Case #: HPC 2018.008
Date: February 20, 2018

PRESERVATION STAFF REPORT

Site: 56 Vinal Avenue

Petition: Jocelyn Siegel, Owner seeks permission from the Somerville Historic Preservation Commission (HPC) to rebuild porches with synthetic materials to meet building code.

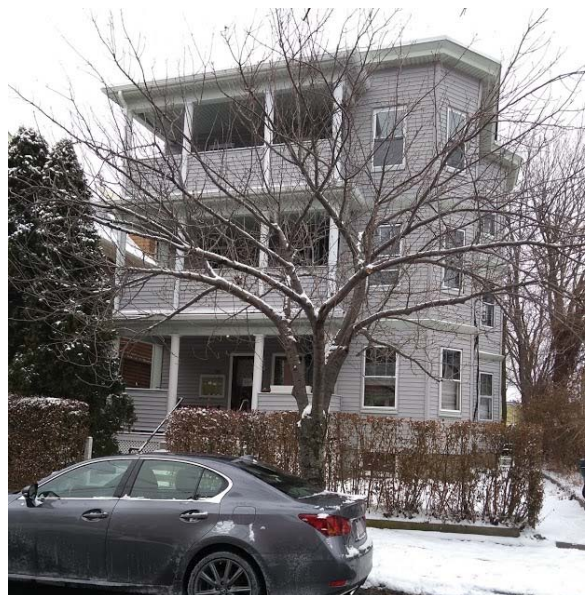
Staff Findings: Staff could not find evidence that any historic commission had approved the use of synthetic decking where it was visible from the street. Staff did find several examples of synthetic materials used for gutters on the condition that it had the correct profile and size and was painted to match the trim.

Staff finds that the proposal does not meet the most basic guideline of repair or replacement with in-kind materials. In this case the materials that had been there until 1996. The proposed material is a synthetic, not wood. The sample was inspected outdoors to ensure that the lighting matched the conditions of use. From a distance, the proposed replacement material has the general appearance of a traditional material but still retains both a glossy and a flat appearance unlike wood. Also, Staff finds the edge of the planks is insufficiently differentiated in color and the texture is flat. Staff also finds that the material when viewed from a grazing angle has a reflective tone that definitely looks like a synthetic material.

Staff finds that the proposed alterations do not meet the above HPC Guidelines to repair or replace with in-kind materials nor does the height meet the historically appropriate ones as seen in the 1989 photo of the building. Staff has suggested that they investigate building railing to the appropriate height with a 'view panel'. The rail height would meet code requirements but would not detract appreciably from the sense of the early 20th century. The Applicant submitted a photo of 42 Walnut Street which has a 42" railing. This property is not a Local Historic District

Based on the information provided and an assessment of the proposal against the Somerville LHD Guidelines, Staff does NOT recommend APPROVAL of the use of AZEK®, Fiberon® or Permalatt® for the front porch. However, Staff does recommend APPROVAL of a Certificate of Appropriateness to return the building incrementally to its original form.

1. All appropriate building permits shall be obtained prior to the start of any work.
2. The existing porch shall be demolished.
3. The porches shall be rebuilt to match the original as seen in the attached photo.

4. All supports shall be hidden behind the skirt and trim.
5. Porch skirts shall oriented diagonally and have a frame.
6. All visible materials shall be wood, preferably of a high quality hardwood with demonstrated durability.

7. Porch columns shall be round with a simple capital.
8. Porch fascia shall be dimensioned to receive the addition of brackets at a future date.
9. Gutters shall be either 4 ½" or 5 ¼" wood profile.

10. The decking on the upper floors may be of synthetic material, providing it is not visible from the public right of way.
11. Railings shall consist of simple hand and foot rails with 2" balusters, spaced to code.

12. The ceilings shall be bead board.
13. Vinyl siding along the porch shall be removed and replaced with wood clapboard painted to match the existing siding.
